ISSUED FOR s4.55(8)  
LODGMENT

DRAWING TITLE			PROJECT
COVER PAGE			VPM
SCALE	STATUS	NUMBER	REVISION
	s4.55 (8)	A0.00	A

S4.55(8) MODIFICATIONS

VPM  
9-11 VICTORIA PARADE, MANLY, NSW

DRAWING TITLE	STATUS	NUMBER	REVISION
FIRST FLOOR PLAN	s4.55 (8)	A1.03	A

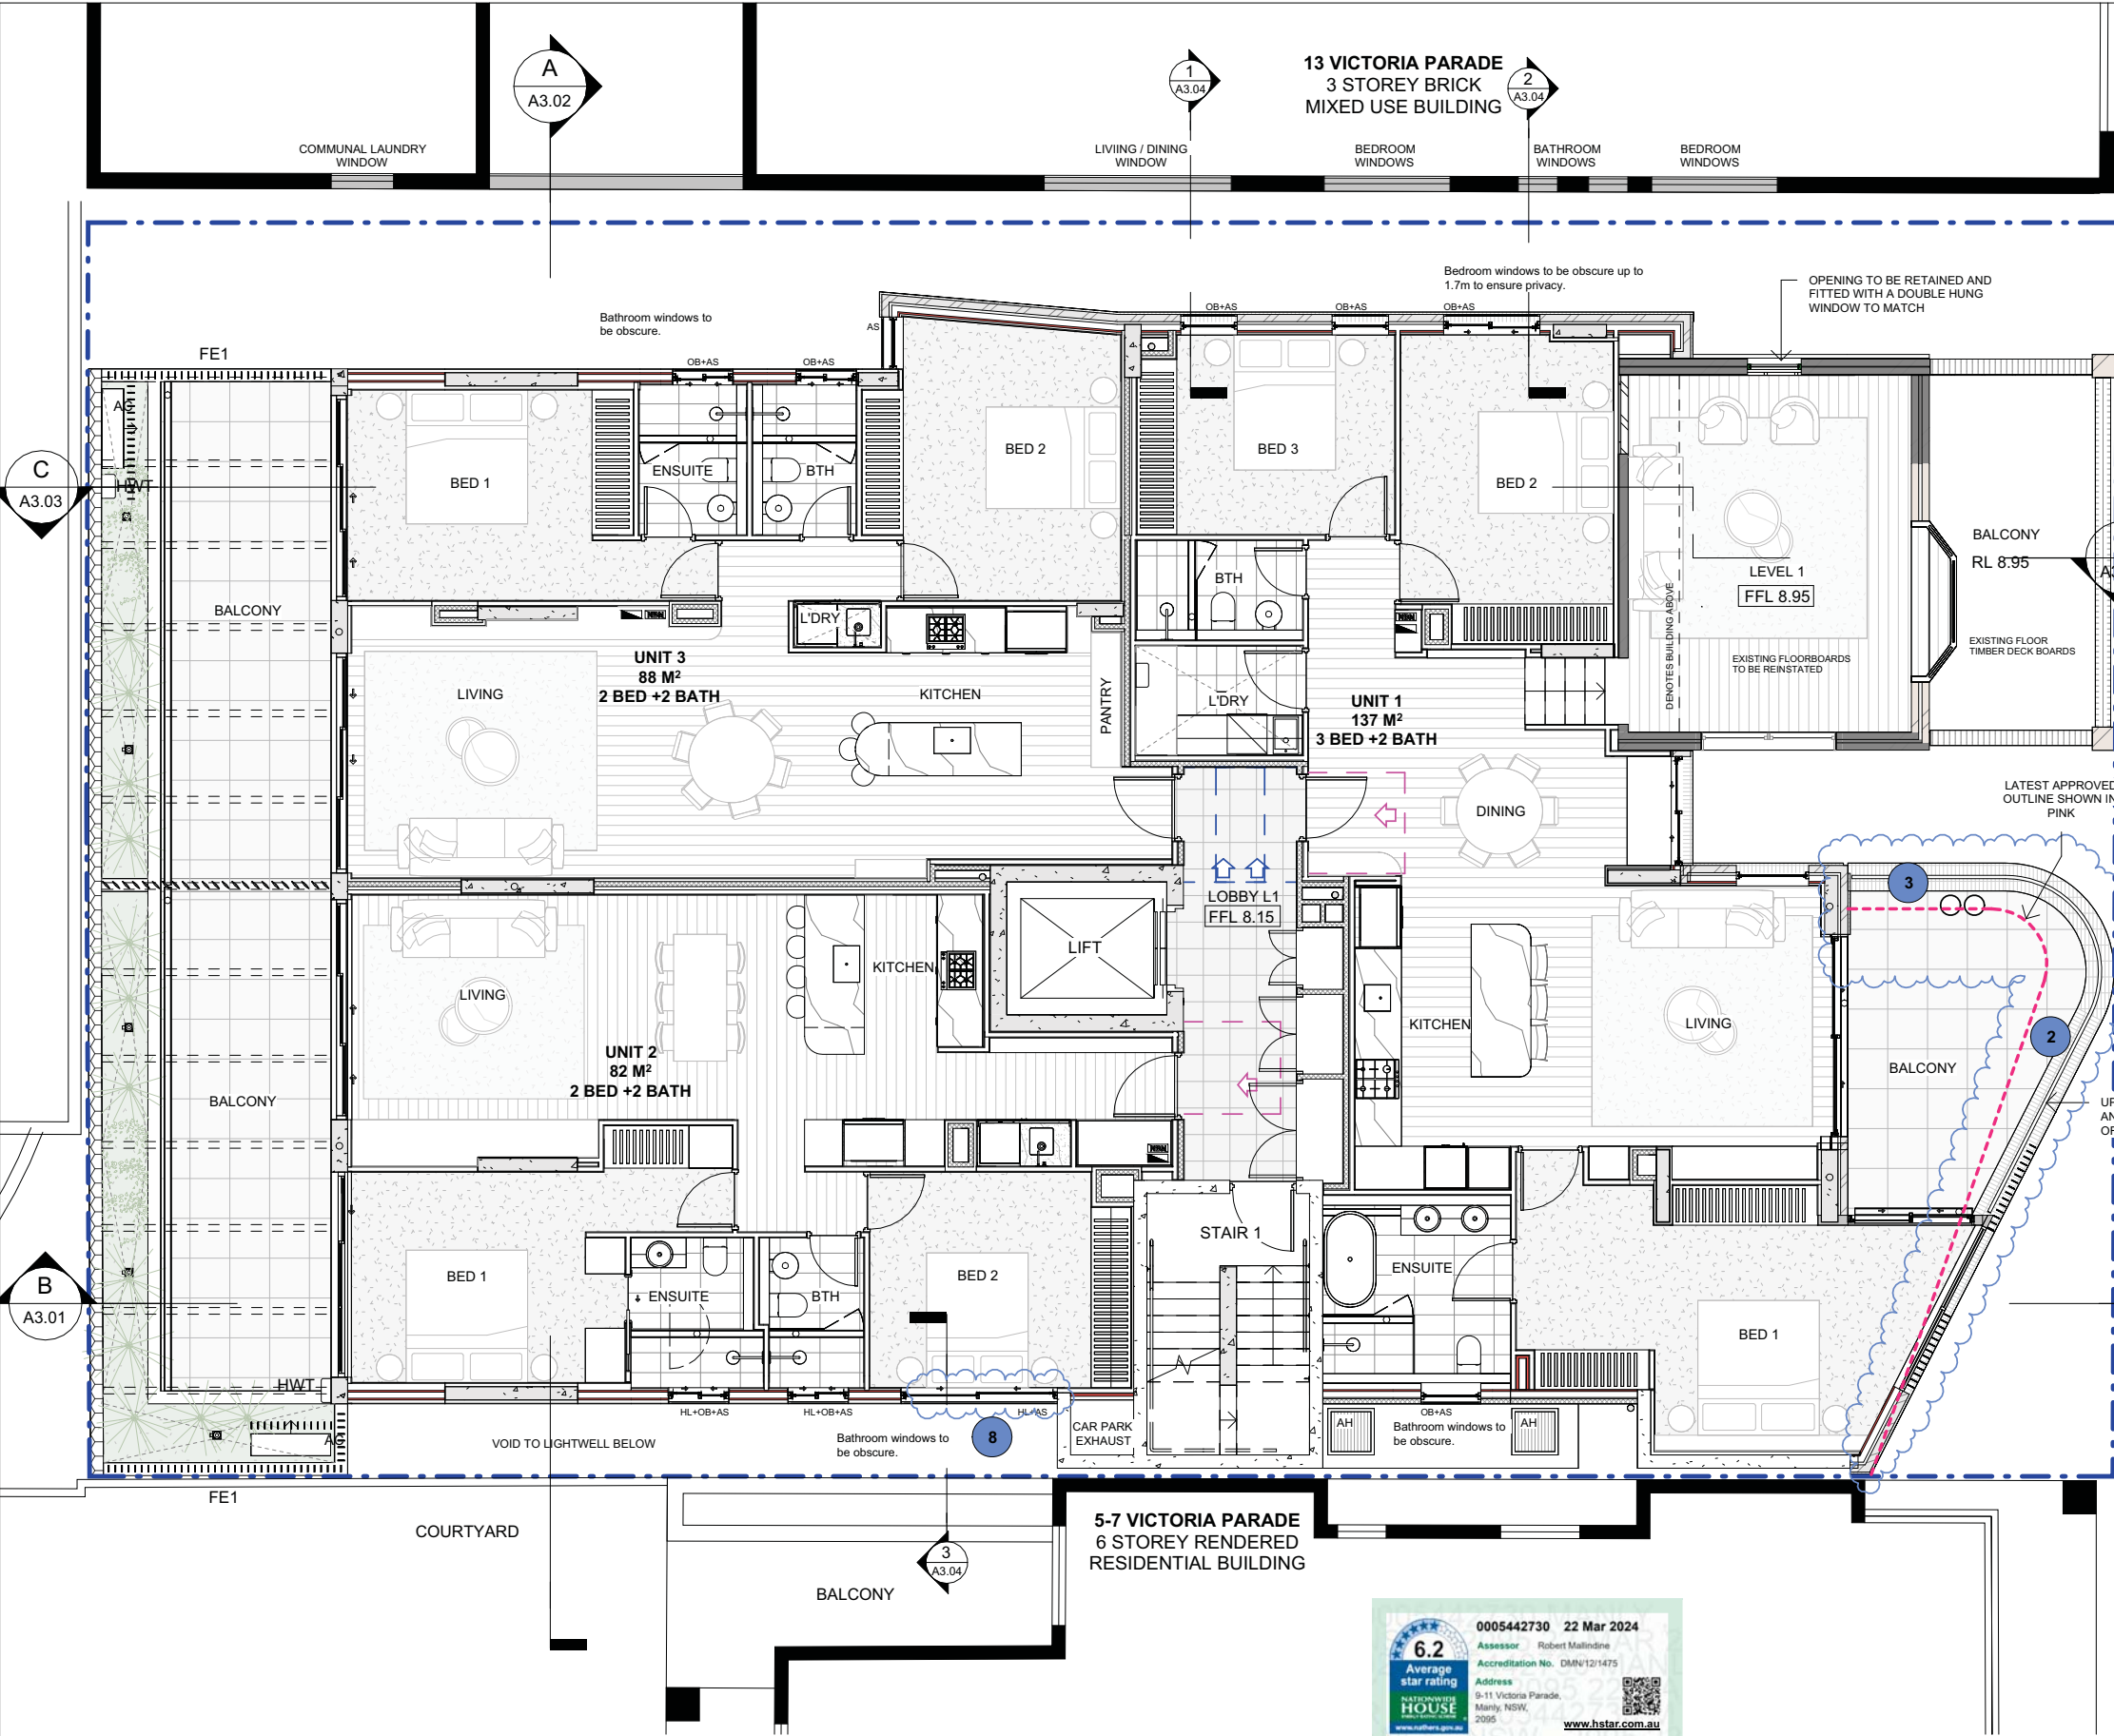
- Retail 1 on Ground floor has been pushed out to enhance the usable area and to suit new columns for balconies above.
- The front facade's angle has been adjusted to enlarge the front balconies and comply with ADG regulations of balcony size.

- Front balconies on level 1 and level 2 were extended to the north east to align with the approved balconies above to avoid looking 'top-heavy' and unbalanced.

- Level 4 brick wall shifted to align with adjacent brick walls.
- Cladding colour proposed to be off-white to visually lighten the bulk of the upper floors.

- Allocation of 1 bicycle space per unit in large storage cages in lieu of separate bicycle parking to satisfy the intention of condition 43D.
- Private roof terrace introduced to improve amenity of unit 14. The glass stair enclosure is not readily visible from the street and has no real impact on privacy, bulk or overshadowing.

- Increase in width of high-light windows to improve ventilation and natural lighting in the bedrooms with no privacy impacts.
- Minor adjustment to the GFA due to the above- still less than LEC approved FSR 3:1.

- Window heads have been lowered to 2.58m to fit services

DRAWING TITLE	STATUS	NUMBER	REVISION
THIRD FLOOR PLAN	s4.55 (8)	A1.05	A

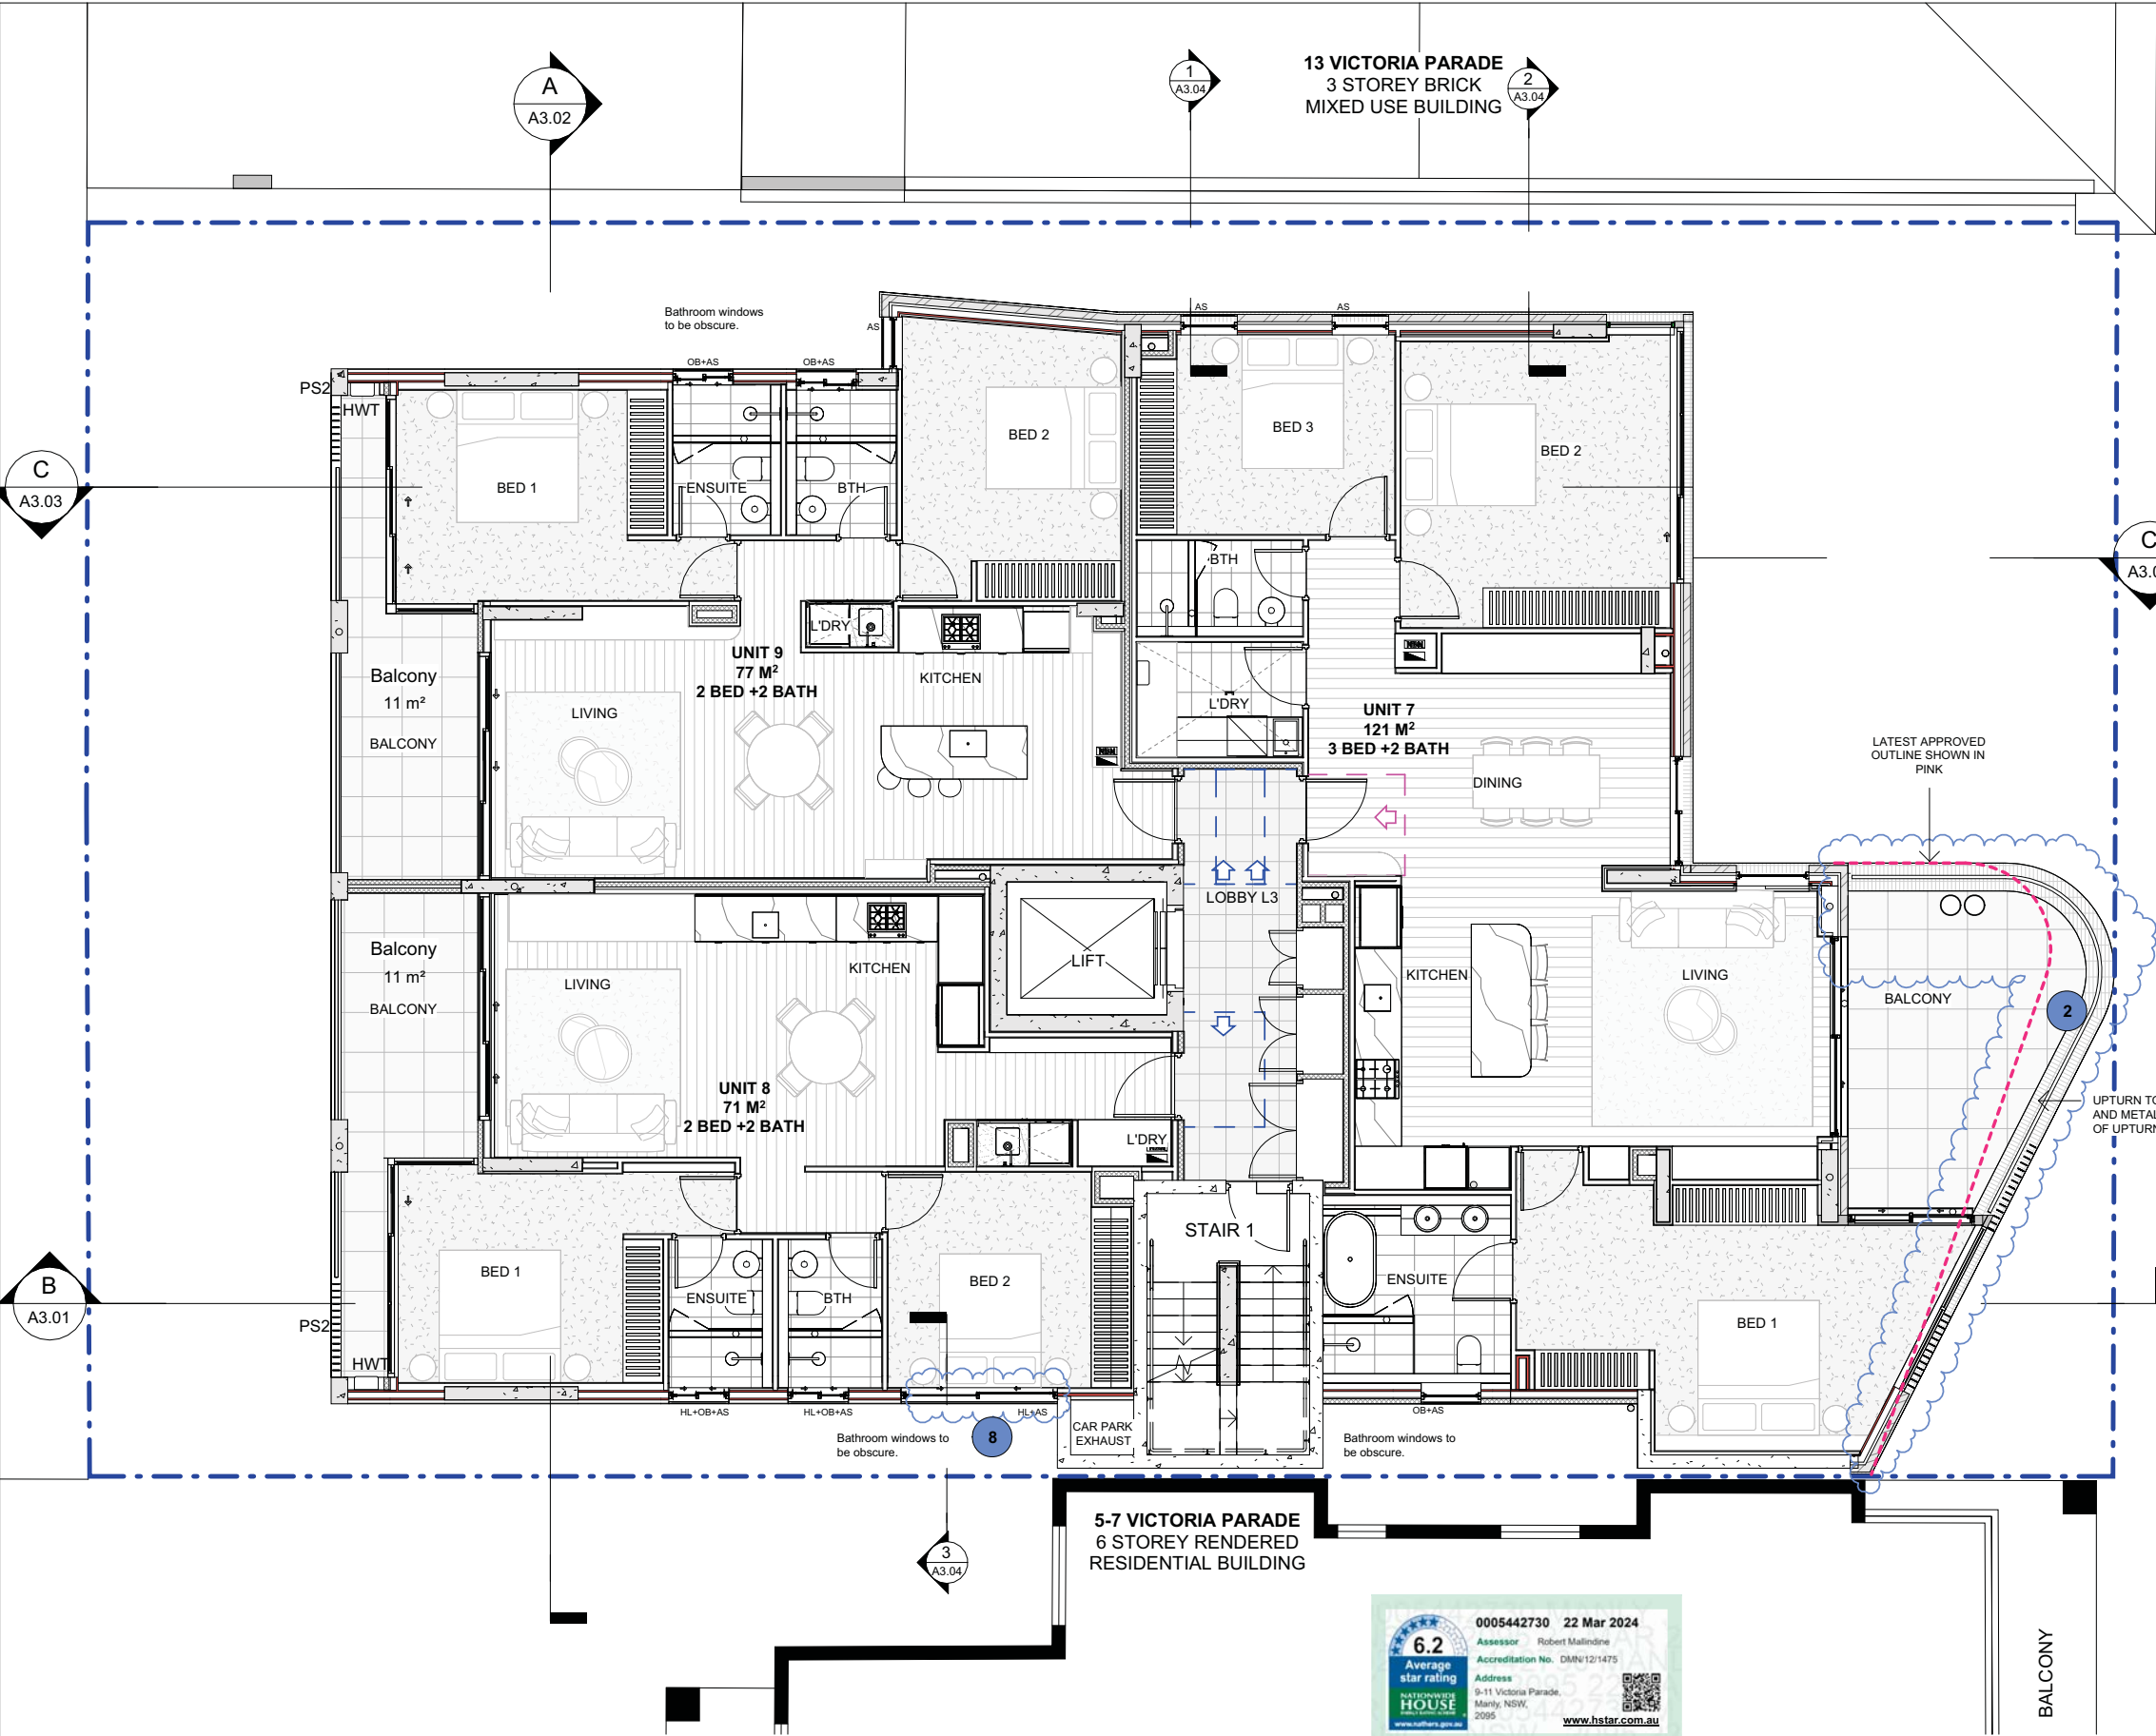
PROPOSED S4.55(8) MODIFICATIONS LIST:

- Retail 1 on Ground floor has been pushed out to enhance the usable area and to suit new columns for balconies above.
- The front facade's angle has been adjusted to enlarge the front balconies and comply with ADG regulations of balcony size.

- Front balconies on level 1 and level 2 were extended to the north east to align with the approved balconies above to avoid looking 'top-heavy' and unbalanced.

- Level 4 brick wall shifted to align with adjacent brick walls.
- Cladding colour proposed to be off-white to visually lighten the bulk of the upper floors.

- Allocation of 1 bicycle space per unit in large storage cages in lieu of separate bicycle parking to satisfy the intention of condition 43D.
- Private roof terrace introduced to improve amenity of unit 14. The glass stair enclosure is not readily visible from the street and has no real impact on privacy, bulk or overshadowing.

- Increase in width of high-light windows to improve ventilation and natural lighting in the bedrooms with no privacy impacts.
- Minor adjustment to the GFA due to the above- still less than LEC approved FSR 3:1.

- Window heads have been lowered to 2.58m to fit services

DRAWING TITLE			PROJECT
FOURTH FLOOR PLAN			VPM
SCALE	STATUS	NUMBER	REVISION
1 : 100	s4.55 (8)	A1.06	A

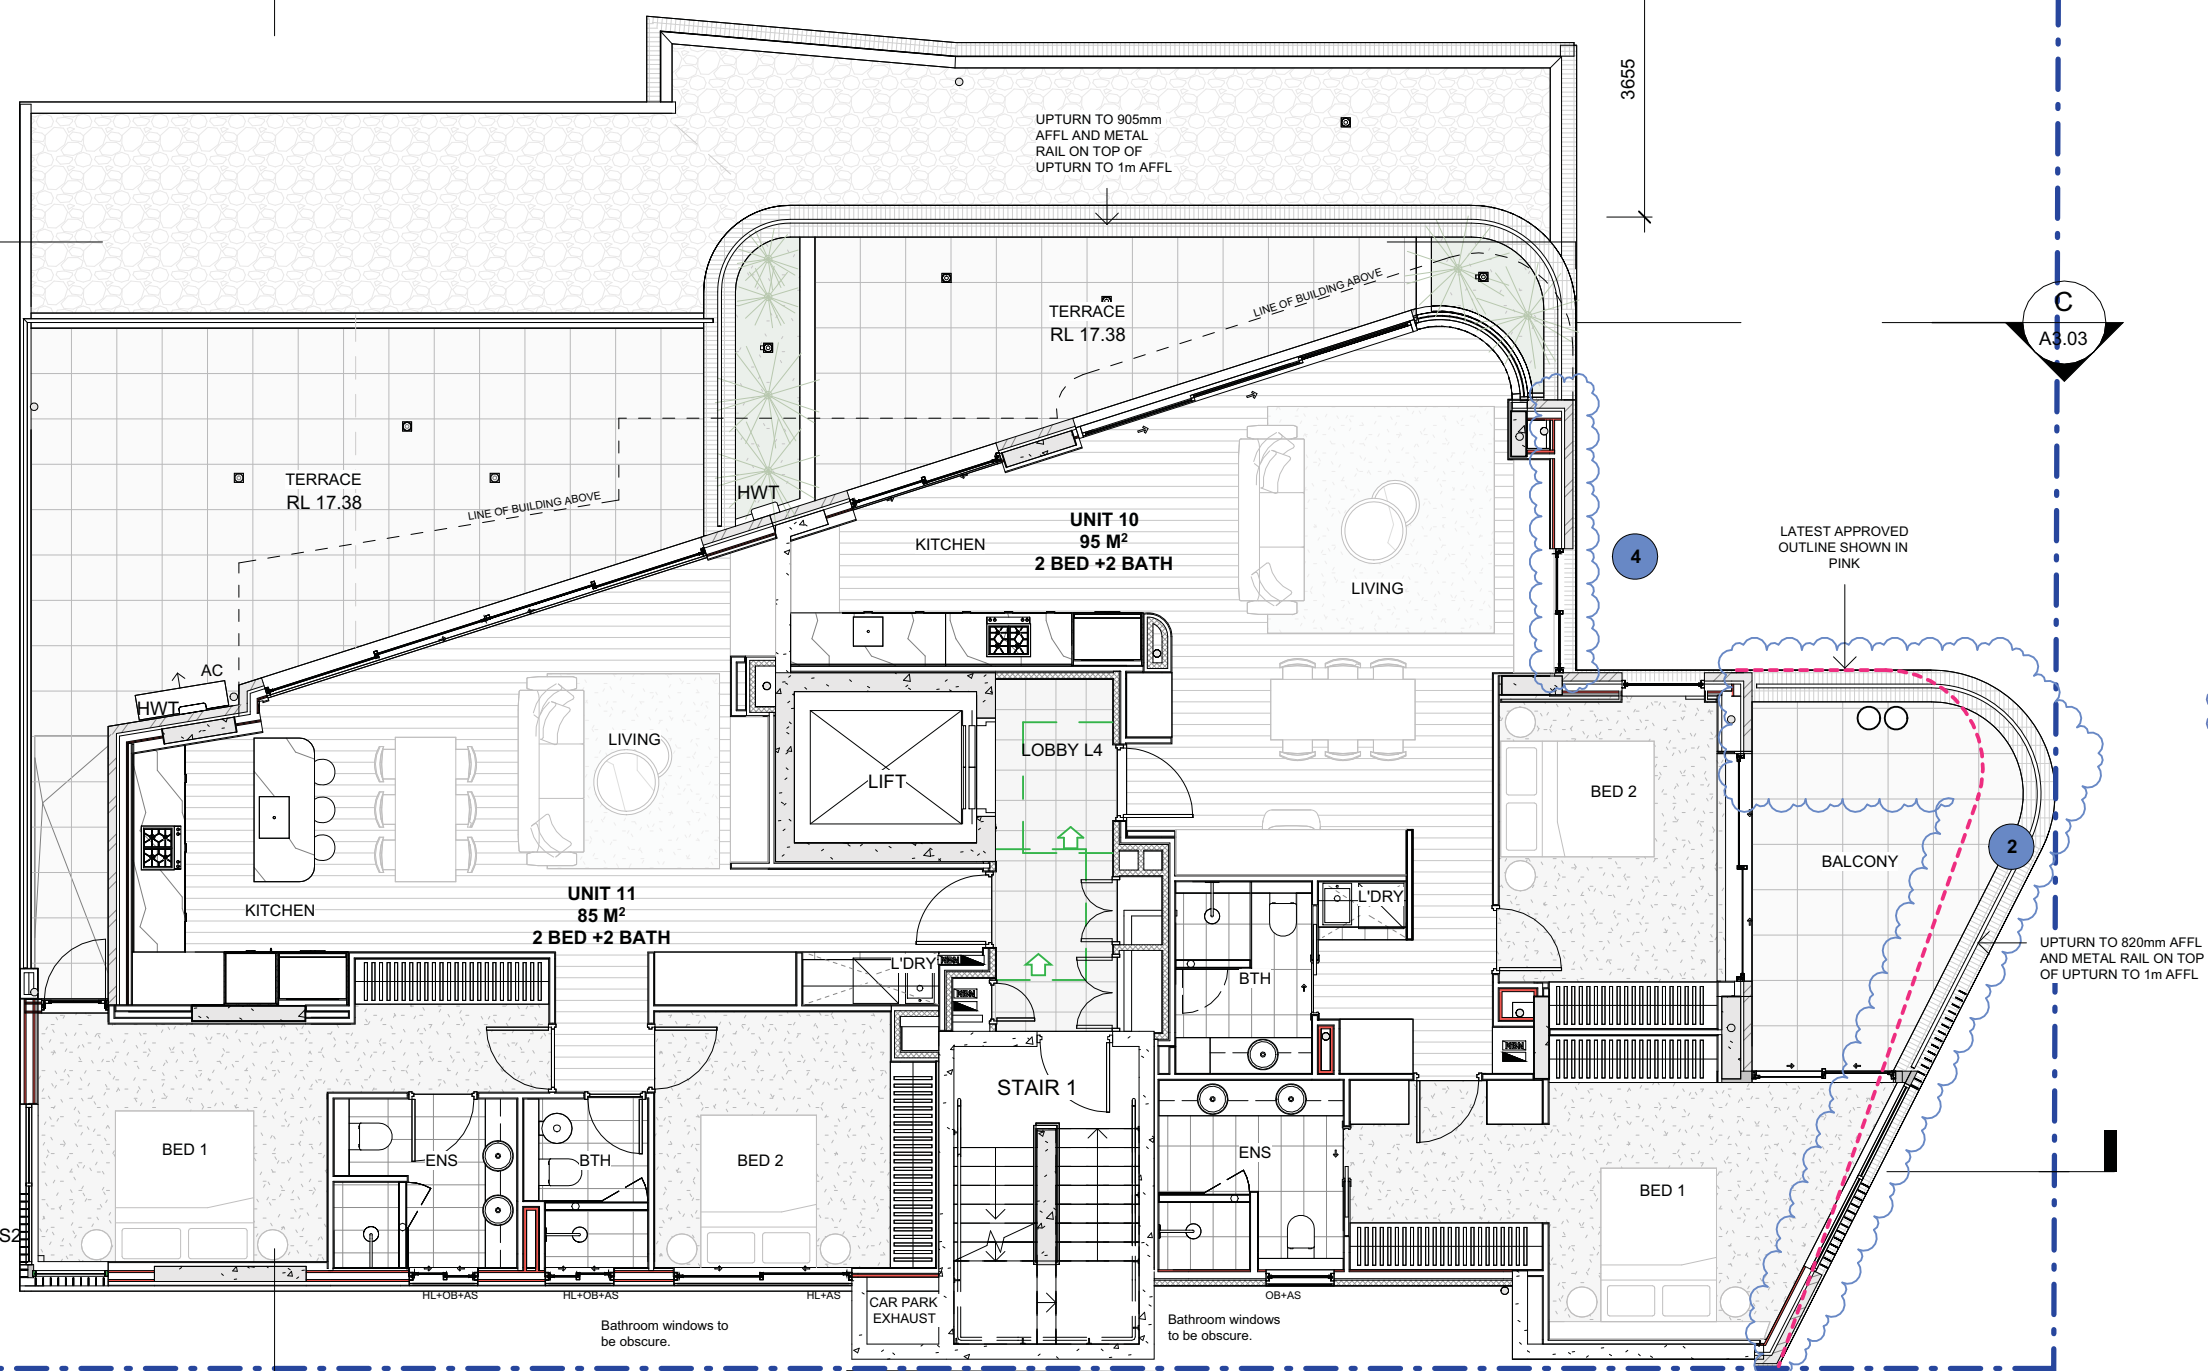
- Retail 1 on Ground floor has been pushed out to enhance the usable area and to suit new columns for balconies above.
- The front facade's angle has been adjusted to enlarge the front balconies and comply with ADG regulations of balcony size.

- Front balconies on level 1 and level 2 were extended to the north east to align with the approved balconies above to avoid looking 'top-heavy' and unbalanced.

- Level 4 brick wall shifted to align with adjacent brick walls.
- Cladding colour proposed to be off-white to visually lighten the bulk of the upper floors.

- Allocation of 1 bicycle space per unit in large storage cages in lieu of separate bicycle parking to satisfy the intention of condition 43D.
- Private roof terrace introduced to improve amenity of unit 14. The glass stair enclosure is not readily visible from the street and has no real impact on privacy, bulk or overshadowing.

- Increase in width of high-light windows to improve ventilation and natural lighting in the bedrooms with no privacy impacts.
- Minor adjustment to the GFA due to the above- still less than LEC approved FSR 3:1.

- Window heads have been lowered to 2.58m to fit services
